CITY PLAN COMMISSION STAFF REPORT

Project Name
Maple Park Plaza

5.1 CD-CPC-2023-00059
Area Plan Amendment
5.2 CD-CPC-2023-00056
Rezoning to UR/MPD

GRADING PLAN
 PROJECT: _____ DATE: 5/16/23
 SHEET NUMBER: **C104**

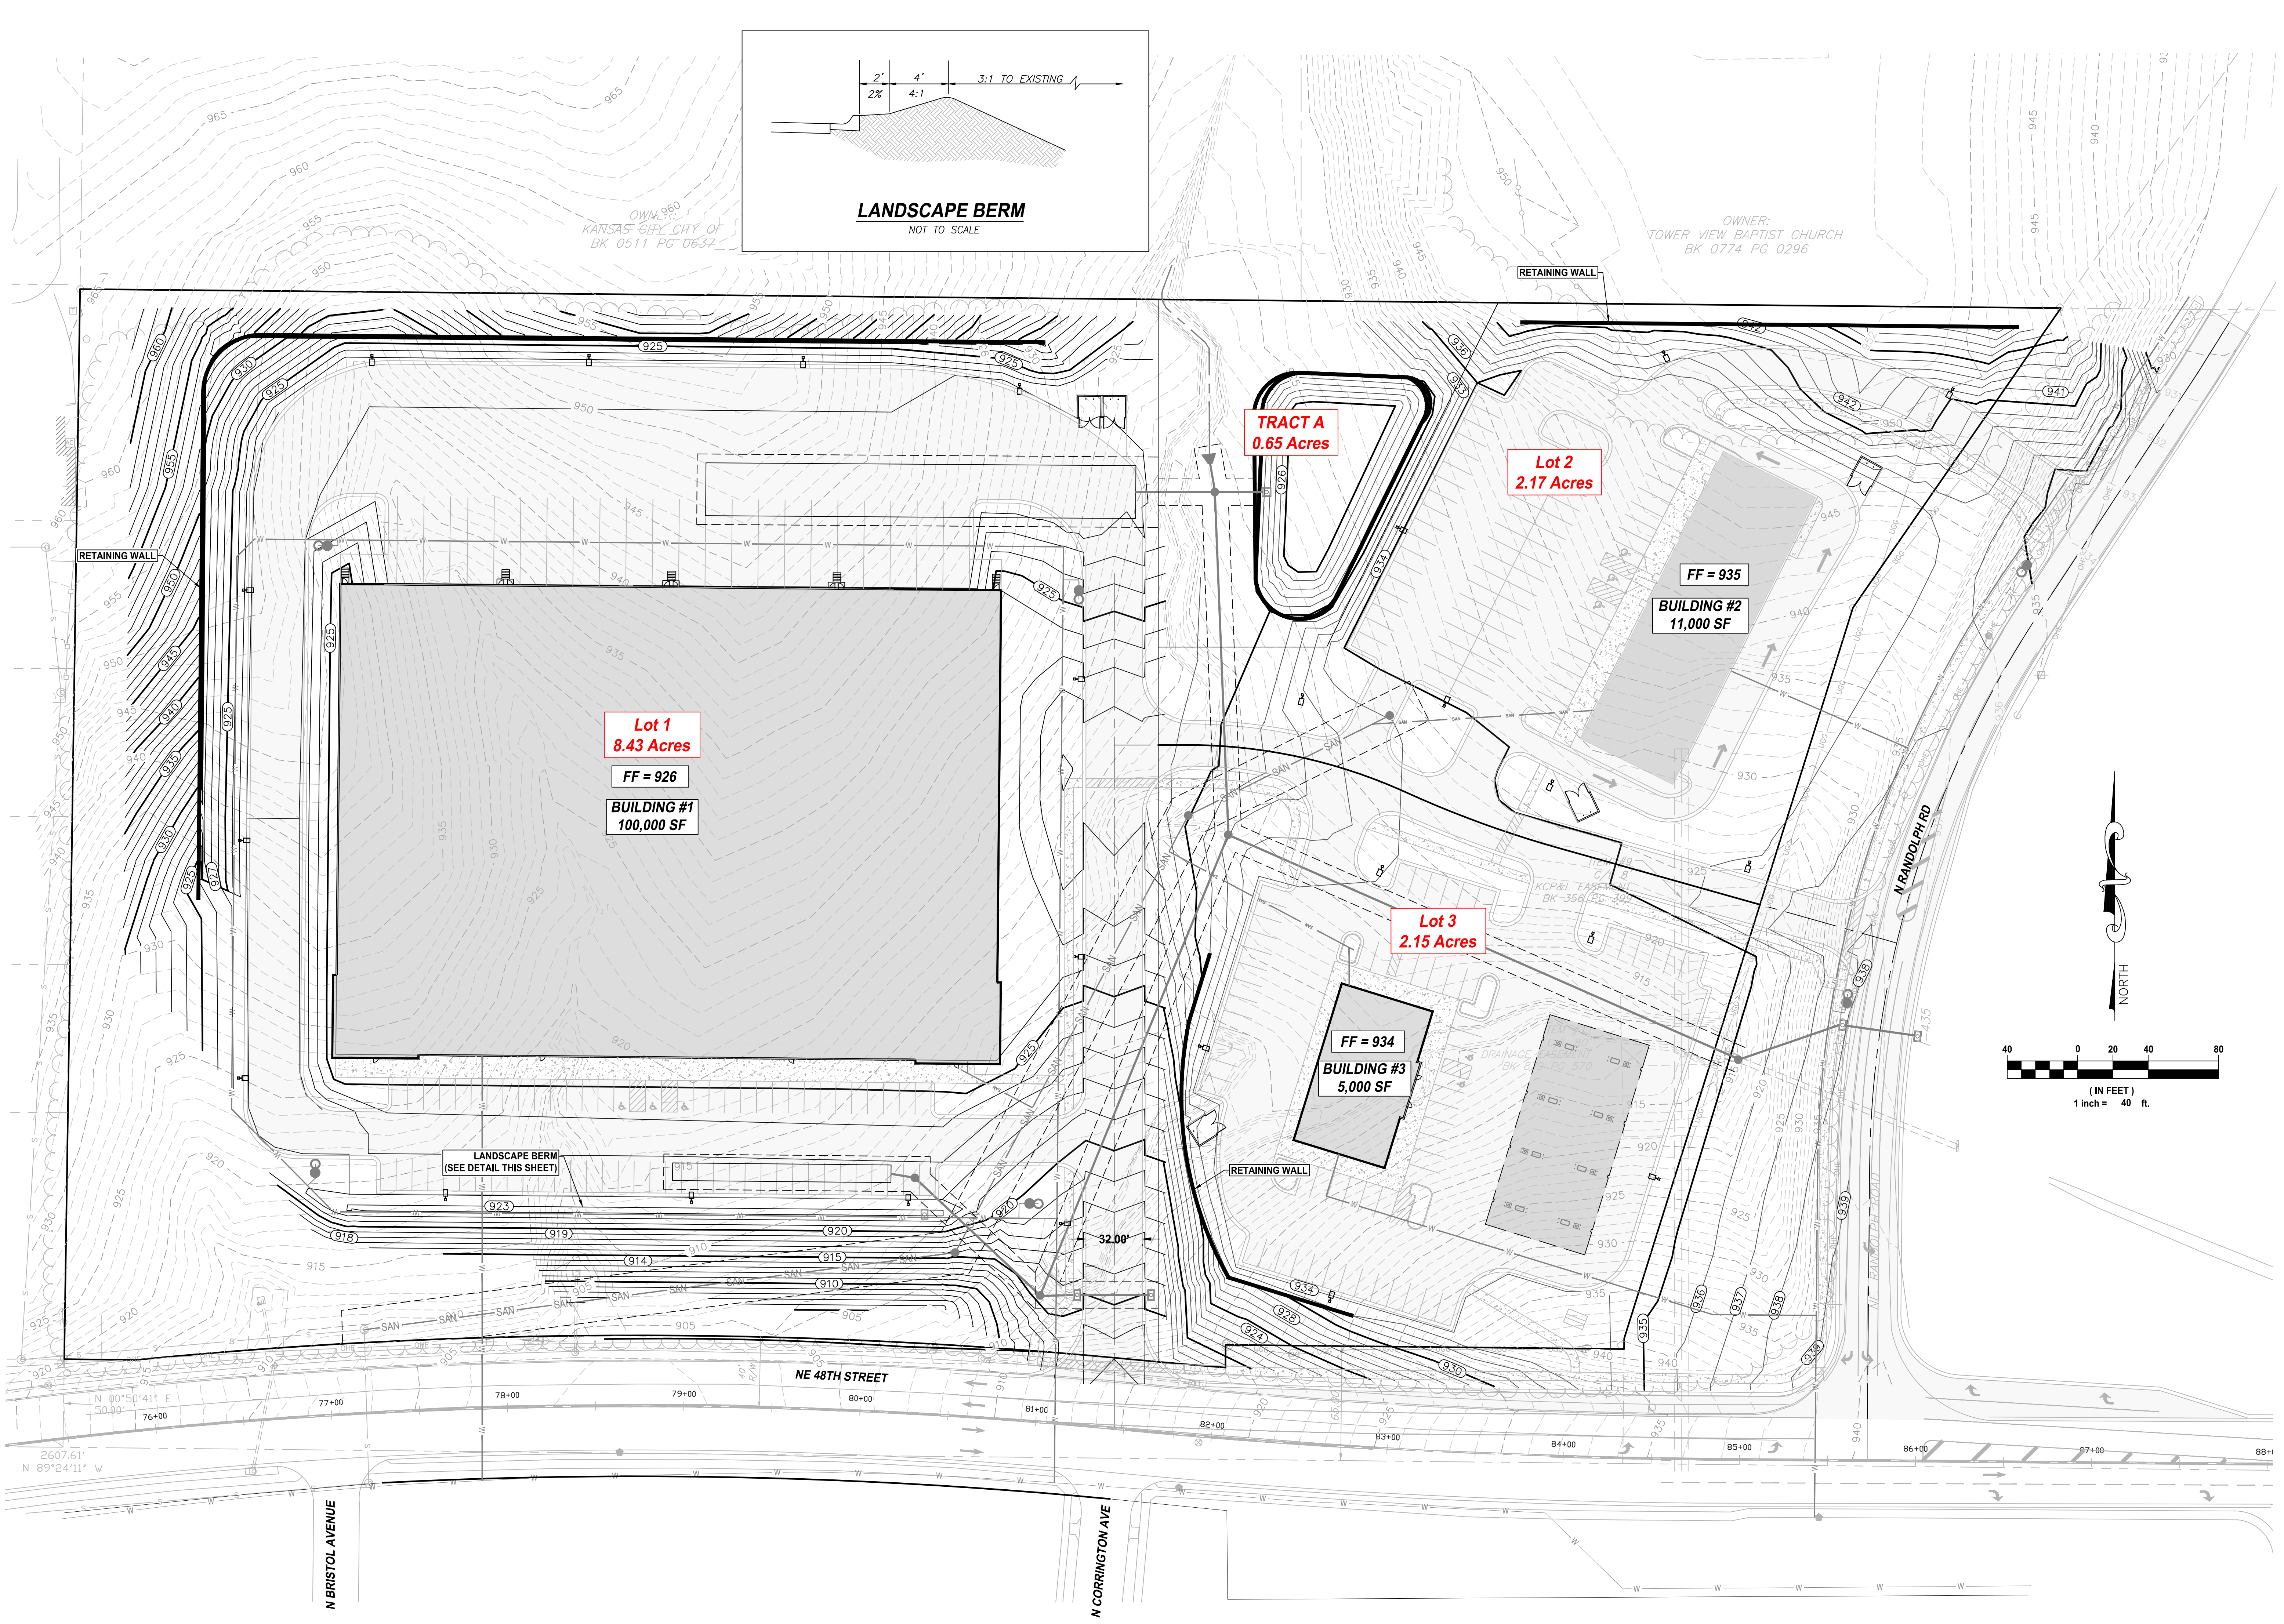
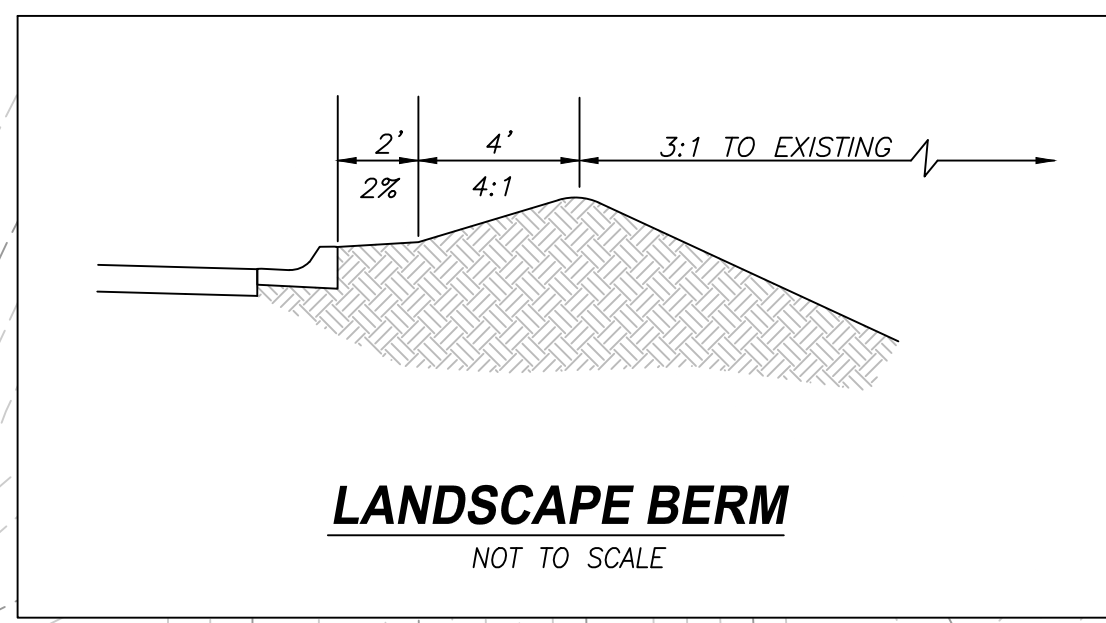
Landscaping and screening is in compliance with 88-425. At staff's request, the applicant added a berm to better screen the proposed industrial building from NE 48th Street. The west side of the industrial building is expected to be primarily screened by the retaining wall due to the 20 foot grade change.
